Subject: Site Review Memorandum
From:  Stephen D. Jarvela, OSC
To: File
Thru: Gregg Crystal, Chief
Eastern Response Section

SUBJECT: Shaffer Electric Site
ERT Review

SITE REVIEW WORK PLAN

**SHAFFER ELECTRIC COMPANY SITE
MINDEN, FAYETTE COUNTY, WV**

U.S. ENVIRONMENTAL PROTECTION AGENCY TECHNICAL ASSISTANCE TEAM - REGION III		DATE	SHAFER EQUIPMENT SITE (smaller located and located not identified)	
MAJOR PROGRAMS DIVISION			MAP	
SITE			DATE	
SCALE			8/14/88	
NEW JERSEY			4463

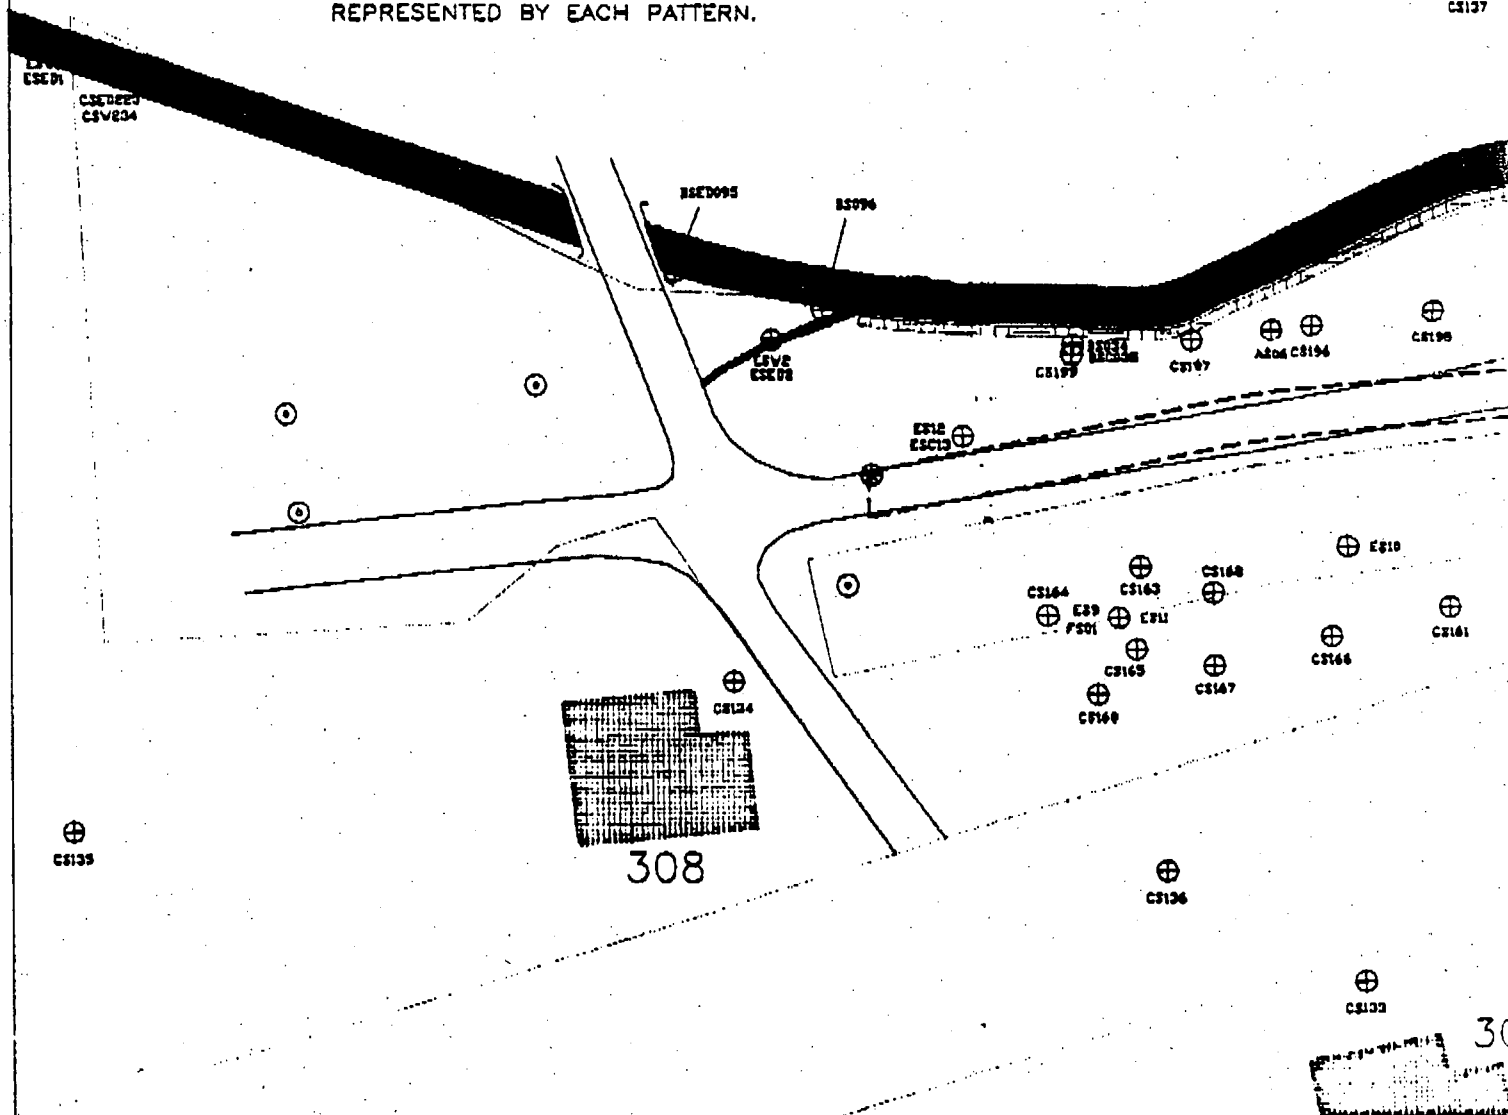
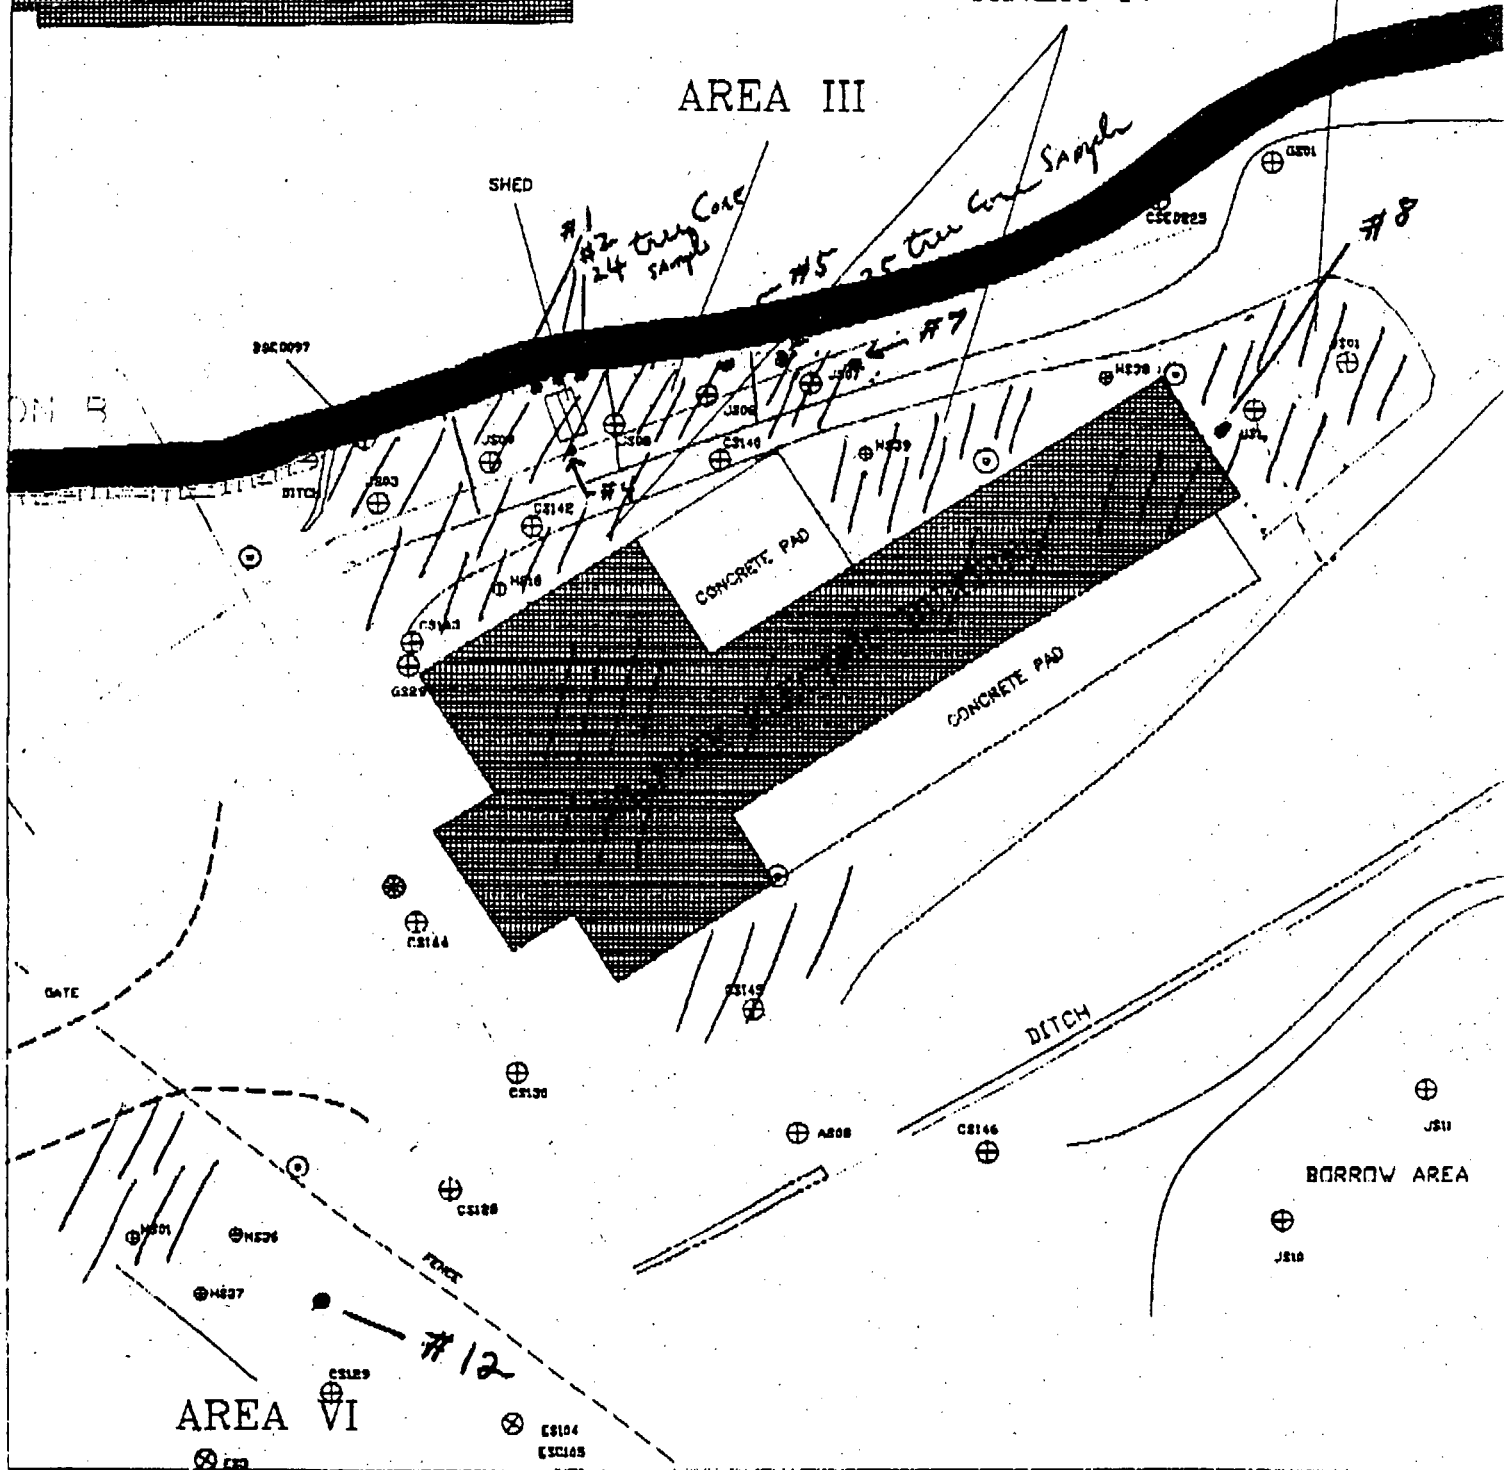
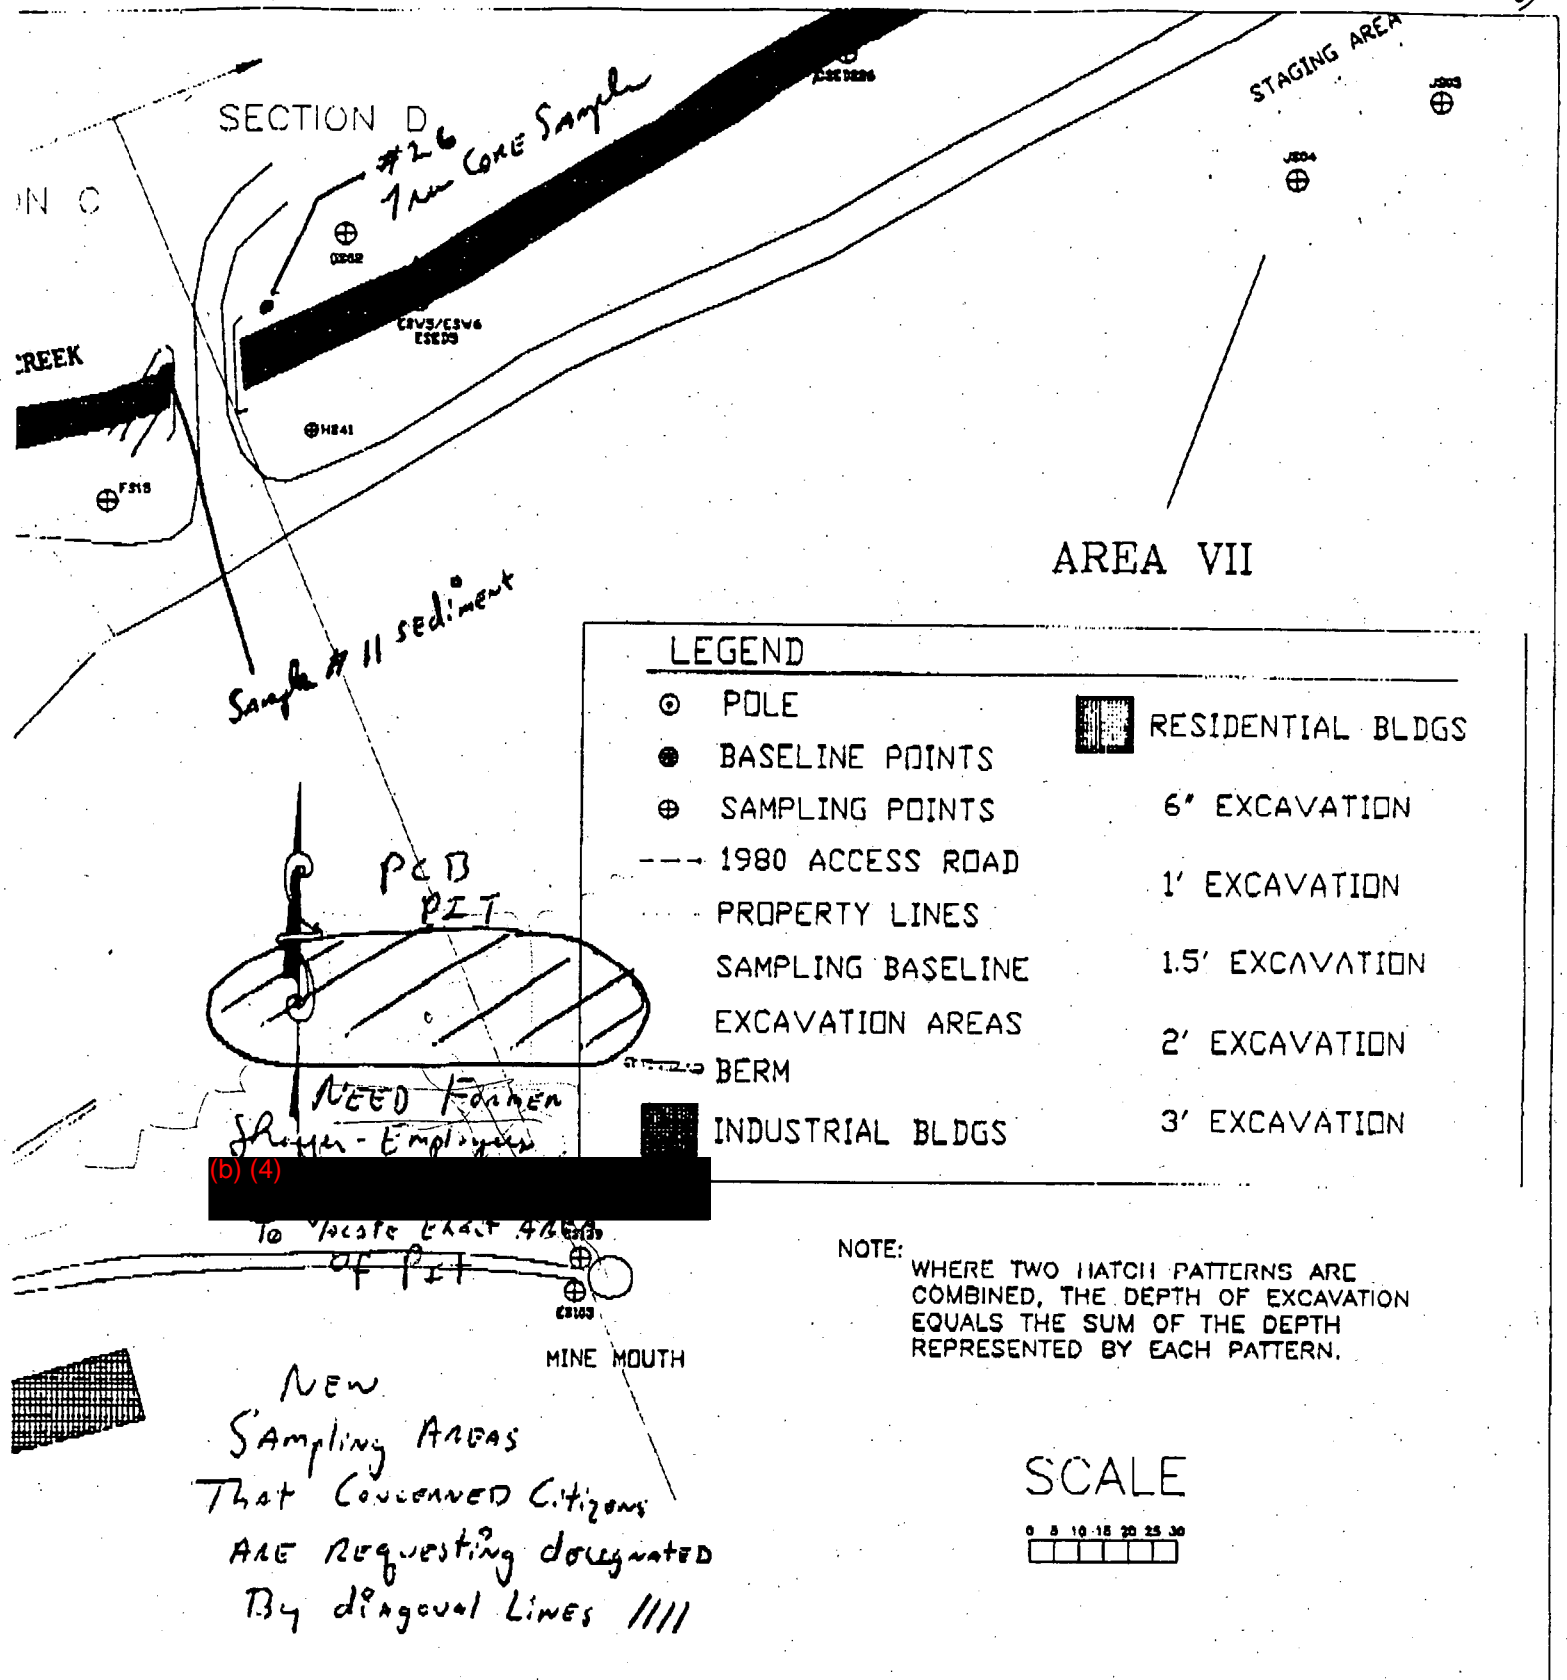
I have transposed to the best of my knowledge the sampling points that Lucian Randall and myself took on July 14, 1991. As you are aware of Virginia Tech, the STEP Project, analyzed the samples for the group. Due to the fact that some samples were broken (samples 3, 6, 9, & 10 - please note the descriptive analysis) the STEP Lab did not report analyzing them. Also, soil sample #14 is not listed as being analyzed. Samples 21 & 22 are unknown for they represent samples 3, 6, 9, 10, and 14 and we do not know which they represent.

The analysis of samples 1, 2, 4, 5, 7, 8, 11, 13, 23 (Mr. Mansfield yard) and the tree bark samples of 24, 25, & 26 do in fact correspond to the descriptive analysis which is included. Thus, I hope that you will be able to discern the locations that we did sample.
